DEVELOPMENT REVIEW COMMITTEE (DRC) COMMENT REPORT

PROJECT NAME: Landmarkdoral Bay 1A Townhomes

CASE NUMBER: UDP-S22049

REQUEST: Site Plan Level II Review: Ten (10) Townhouse Units

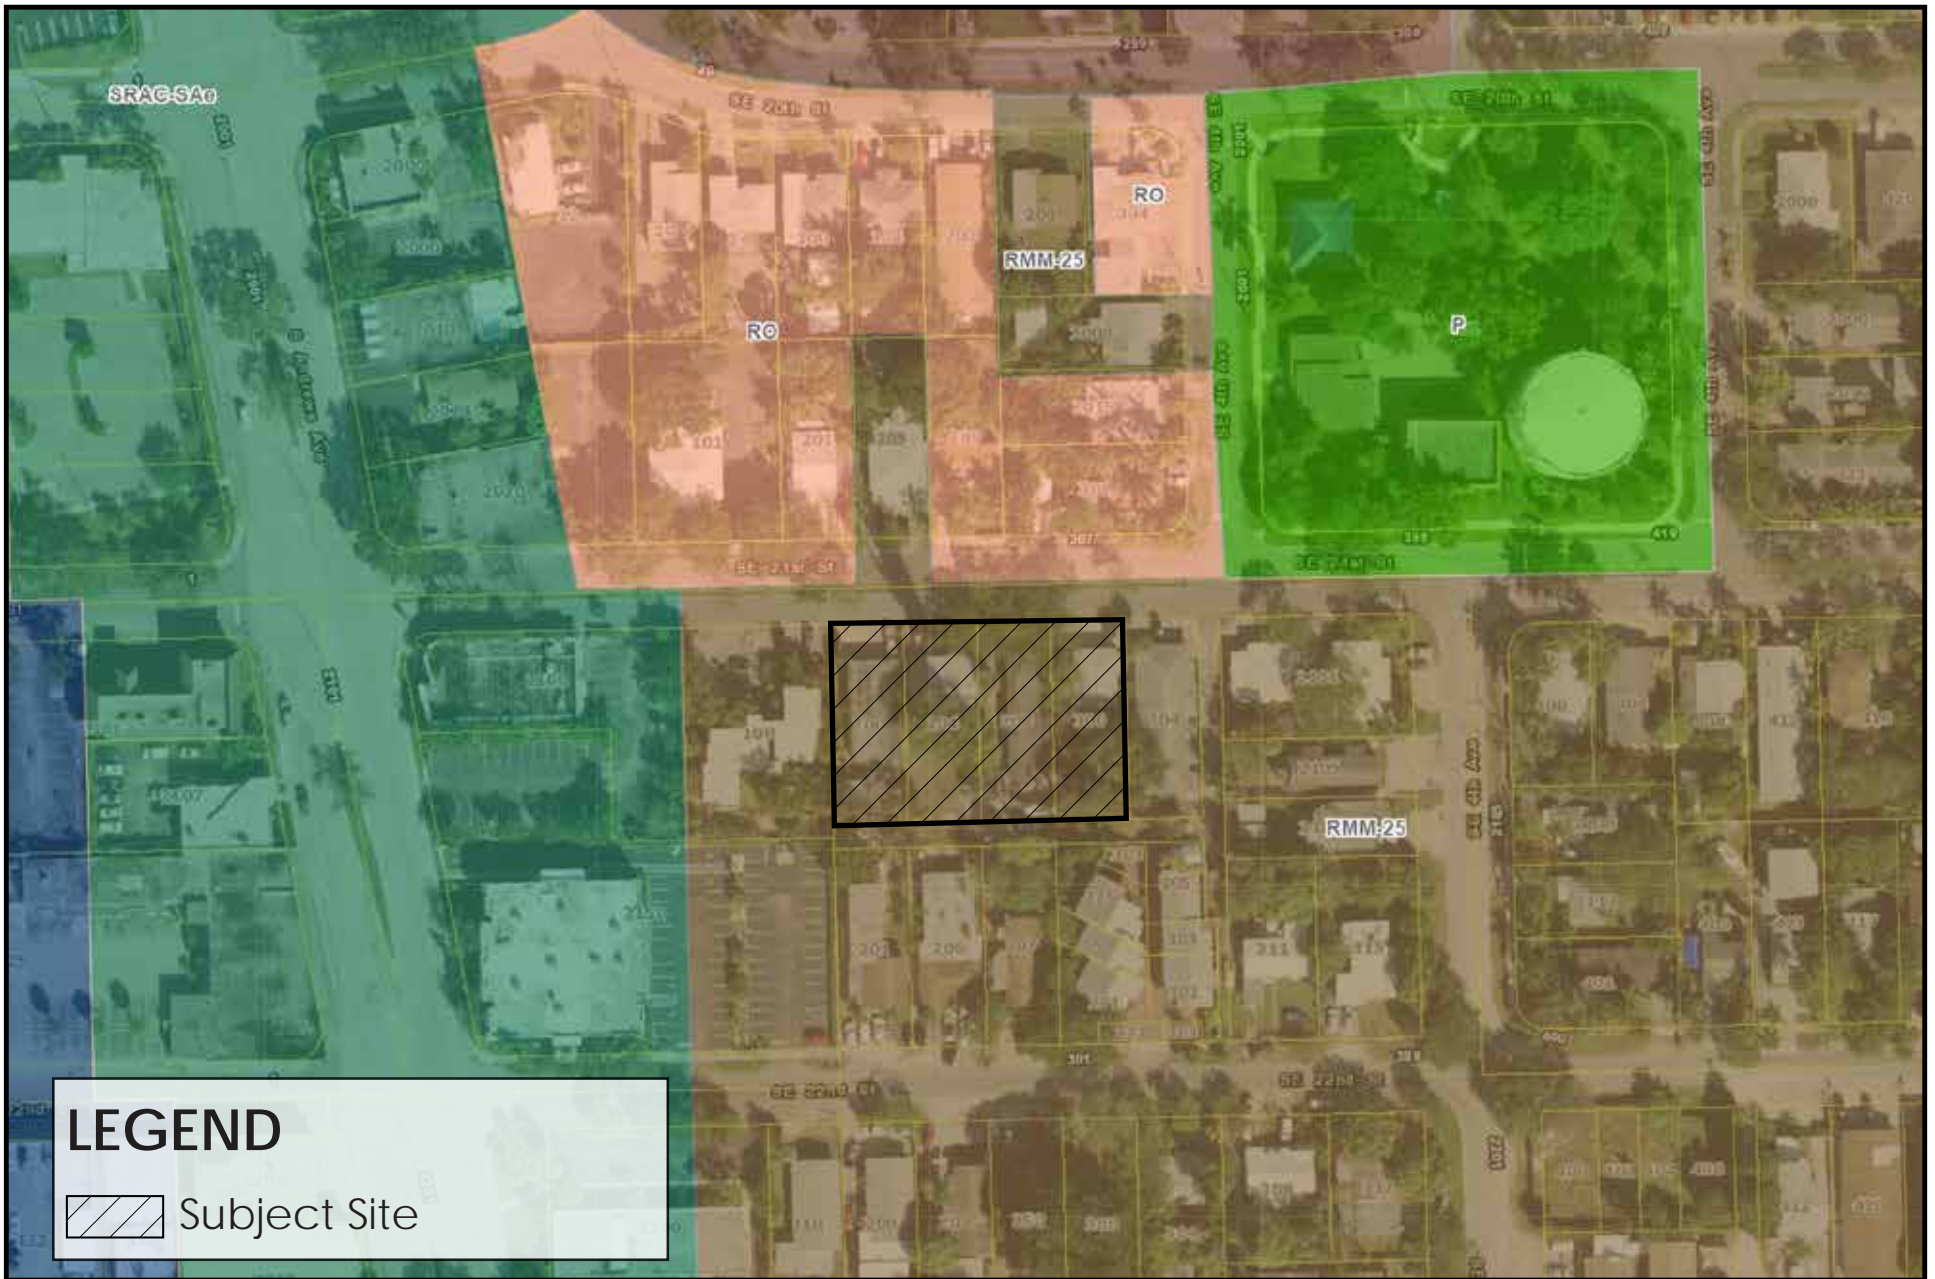
- 13) Provide details of proposed fence and retractable gate.
- 14) Pursuant to ULDR Section 47-19.2.Z, Accessory Uses, Buildings, and Structures; rooftop mechanical equipment such as air conditioners, compressors, generators, etc. shall be screened with material that

matches the material used for the principal structure and shall be at least six (6) inches high above the top most surface of the roof mounted structures. Provide the following:

- a) Provide screening product material including images or pictures of actual application of such; and,
- b) Show height of rooftop screening.
